Our Ref: 110965.04-Westlink ST2 Trunk Drainage - Response to SW comments.docx
PJM:pjm

Subject: Westlink Stage 2 - Drainage Channel Works DA Design Plans (Council Ref: SSD-9138102)

ATTACHMENT B

ATTACHMENT A - WESTLINK – INDICATIVE ESTATE PLAN

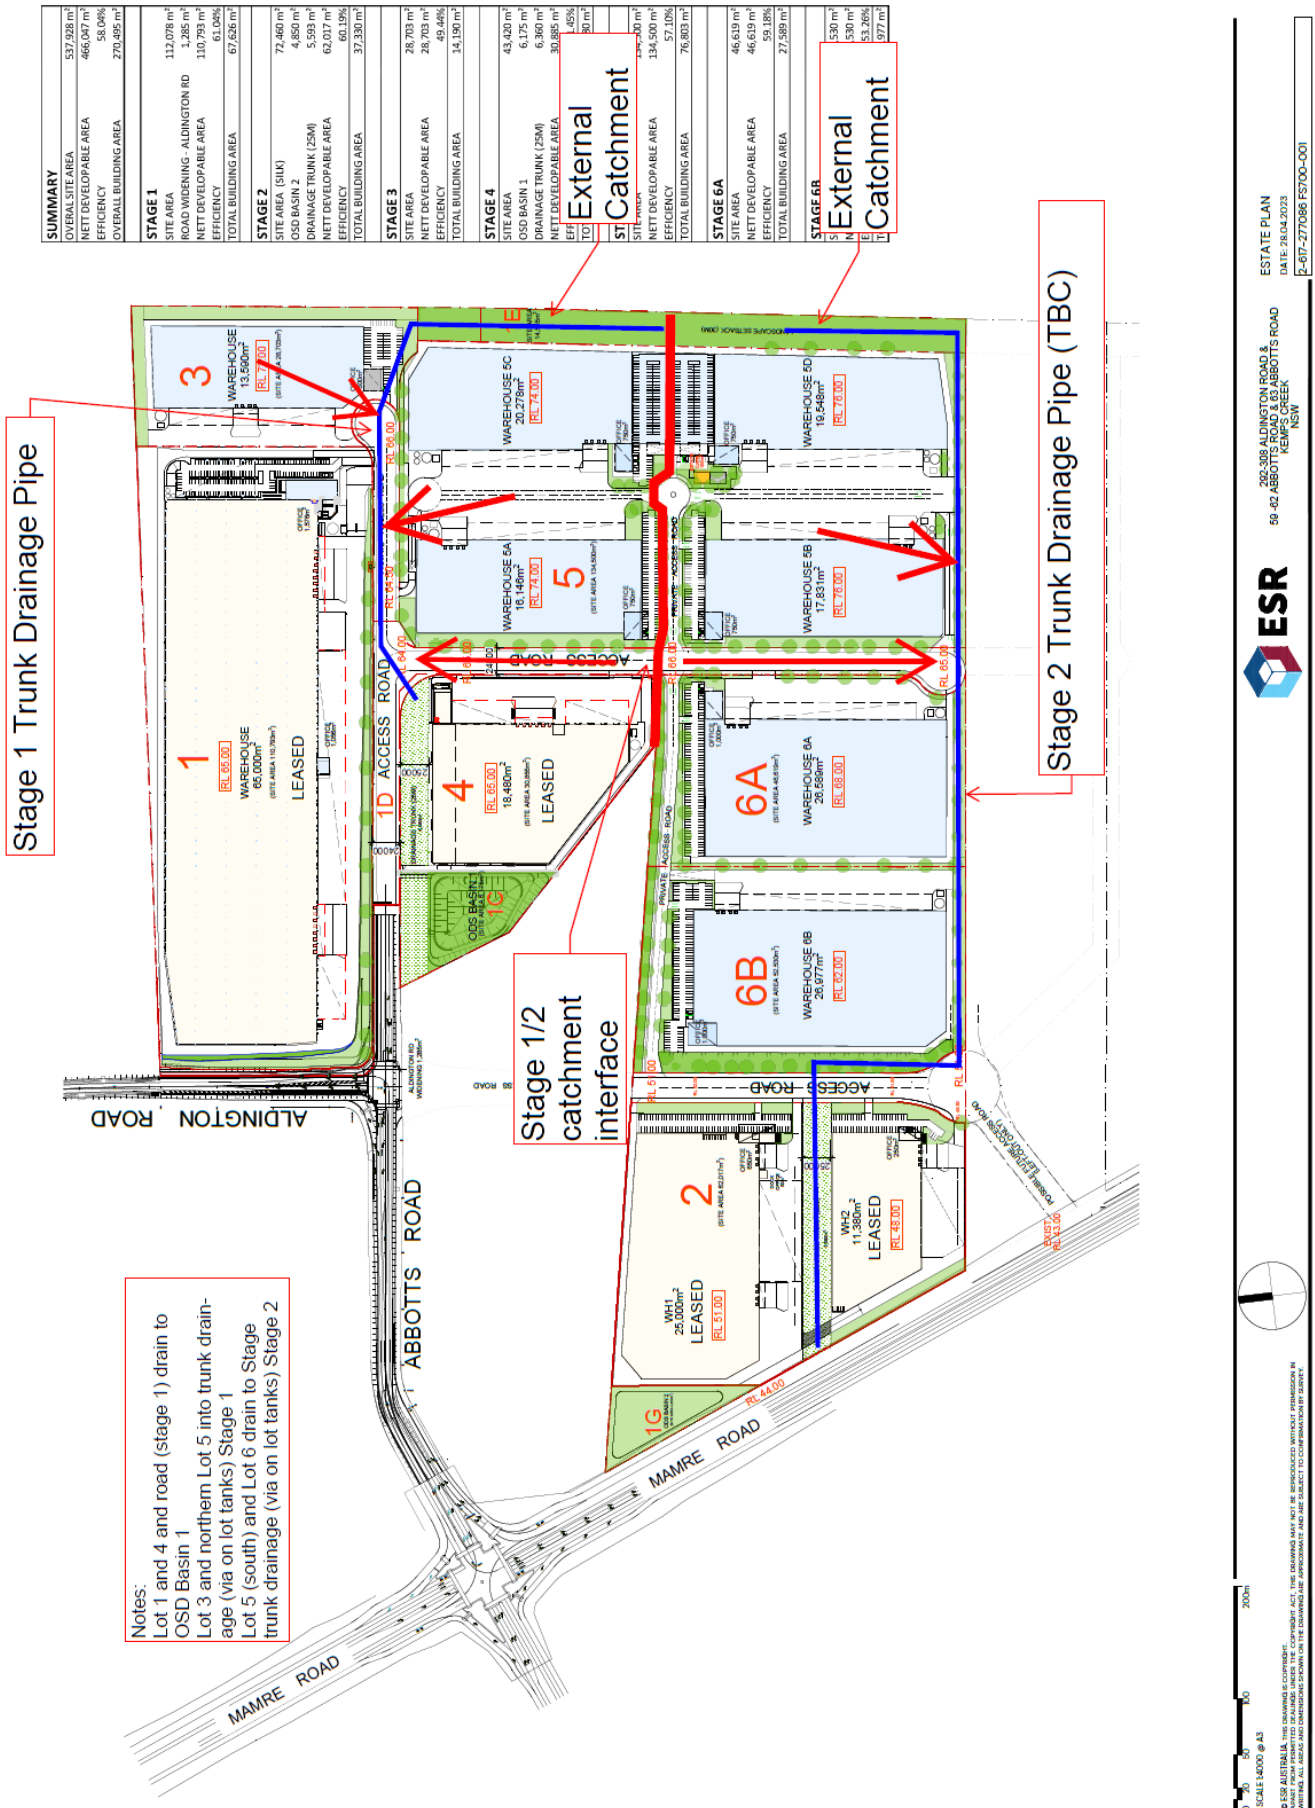
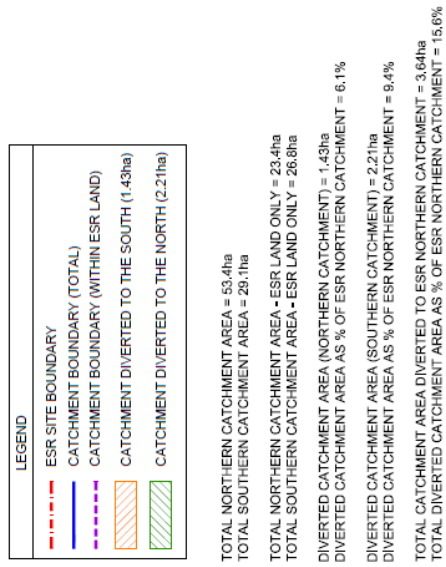
7.	Westlink Broader Drainage Strategy	Noted	
	<p>JWP/ESR to outline the modified intent of the Stormwater management arrangements intended during subsequent development stages (i.e. 3 and 5) likely to drain into the Stage 1 drainage channel (OSD approach, external catchment management, pipe connections etc)</p> <p>On 24/5 JWP presented a sketch plan showing the current general arrangement for the remaining stages at Westlink. A copy of his sketch plan is provided in Attachment A. It should be noted that this plan is indicative only and may be adjusted to suit future specific development requirements.</p>

ATTACHMENT B - WESTLINK – CATCHMENT REDISTRIBUTION

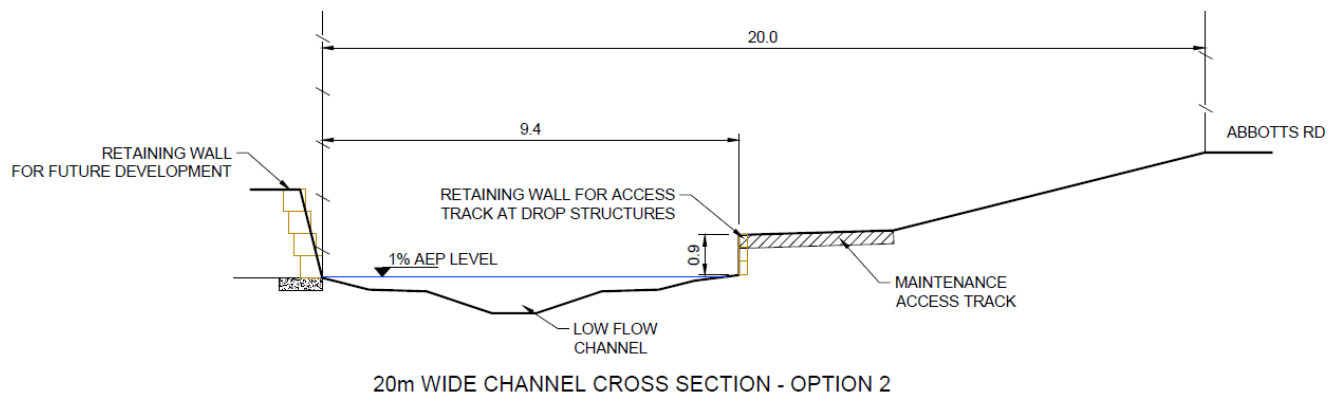
8.	Catchment Redistribution	Noted	
	<p>Consistent with Sydney Waters verbal advice at the meeting of 17/4/23 ESR is proposing to redirect a maximum of 10% of the catchment areas discharging to each channel when compared to the post-development catchments detailed in the IWCM strategy.</p> <p>JWP issued an email and plan outlining intended catchment diversions on 18/5. On 24/5 SWC requested further details clarifying the treatment of the catchment in the NW corner of the Westlink site. JWP updated and reissued the plan to Sydney Water on 26/5. A copy of his sketch plan is provided in Attachment B.</p> <p>SW noted (AT email 30/5) that the proposed catchment redistribution exceeded the agreed 10% permissible limit but nevertheless confirmed that in this instance SW could facilitate the proposed change to catchments</p>

ATTACHMENT C - WESTLINK – 20 m CHANNEL OPTIONS

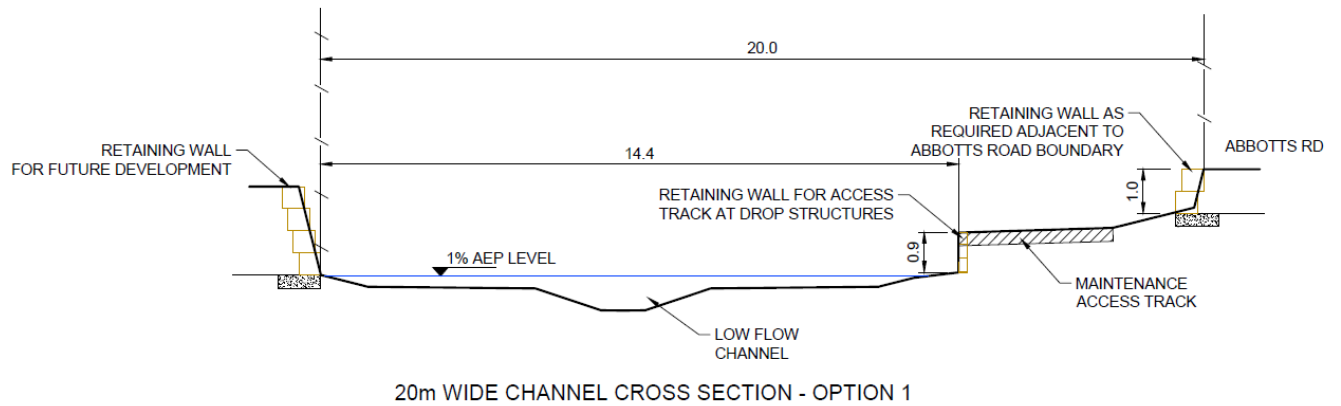
5.	Channel Width		
5.1.	Would a reduced channel width be permitted for Stage 1 if we can demonstrate that the flows are contained, and the design complies with the technical guidelines?

<p>SWC was inclined to agree with a reduced channel width (down to a min 20 m) where flows permitted.</p> <p>SWC was currently reviewing the precinct hydrology modelling to confirm appropriate modelling parameters.</p> <p>To allow advancement of the channel design within the required timeframes for Stage 1:</p> <ul style="list-style-type: none"> • SW (PG) provided details of the flows they had previously estimated at Aldington Road on 18/5. (Pre-development 1% AEP = 5.1 m³/s at Aldington Rd) • AT&L prepared a brief summary letter outlining key hydrologic modelling parameters applied to the DRAINS modelling for Westlink and the stage 1 channel. GM issued this to SW on 15/5. • JWP confirmed the adoption of AT&L's pre-development 1% AEP flow estimates of 7.2 m³/s at the western boundary for the design of the entire trunk drainage channel. • SW (JM) responded with initial comments by email on 25/5 to specific questions raised by AT&L relating to broader precinct scale hydrology for the Mamre Road Precinct. SW advised AT&L there would be further advice forthcoming on losses to be applied in the hydrological modelling. • JWP (DG) presented two alternate channel sections by email 5/6 that achieved a 20 m TD corridor width while complying with design arrangements agreed in principle (Option 8). Indicative cross sections of each option are provided in Attachment C. • SW to review and confirm the preferred Option. • SWC requested additional information on the 20m wide channel options, including overbank velocities for the establishment phase, channel profiles with additional profiles overlaid (Abbotts Road CL, boundary, maintenance track and channel banks) and preliminary hydraulic results. • JWP provided the additional information above along with 3D images of the channel profile. SWC to review and confirm the preferred option. • SWC agreed to the Option 1 20 m wide cross section at the meeting of 14/6/23. 	JWP (Integrate into Design)

<p>It is noted that the options canvassed are site-specific solutions only and would not be applied to locations further downstream on this channel (nor on channels in future stages) where more reasonable channel gradients are possible.</p> <p>JWP discussed two refined variations of the Options based on Option 2 and a new Option 7 (as for Option 6 but with 2% max grades and 0.9 drops) at the meeting on 18/5. JWP refined these further based on Sydney Water feedback and assessed compliance against SW design parameters for the ultimate and establishment phases of the channel. Updated details were issued by email by PM on 22/5. (a copy is also attached to minutes No 3)</p> <p>SW (PG) raised concerns regarding Option 2 and the risks of erosion of the soil/rock interface associated with longitudinal grades of 6.8% on dispersive clays. SW confirmed maximum longitudinal grades of 2.0% would be acceptable.</p> <p>On 24/5 JWP issued an email to SW with updated details for "Option 8" which is a hybrid of Option 2 and Option 7 having max grades of 2.0%. A copy of his sketch plan is provided in Attachment C.</p> <p>SW confirmed acceptance of Option 8 in principle (AT email 30/5) and advised that at detailed & construction design stages, the channel must be designed to Sydney Water's specs which is currently under development.</p> <p>JWP (DG) issued Channel concept design plans to Sydney Water on 26/6/23. This was followed with a high-level concept design for the extension of the channel to Mulgoa Road on 27/6/23.</p> <p>SW (AT) provided minor comments back to JWP on 5/7/23 and after consultation with AT&L on the OSD basin channel interface updated designs were prepared and issued by JWP (DG) on 7/7/23. [JWP Ref: 110965-03-DD001-DD072]</p> <p>SW confirmed acceptance of the JWP concept plans for the naturalised trunk drainage channel at the project meeting of 12/7/23</p>	Noted
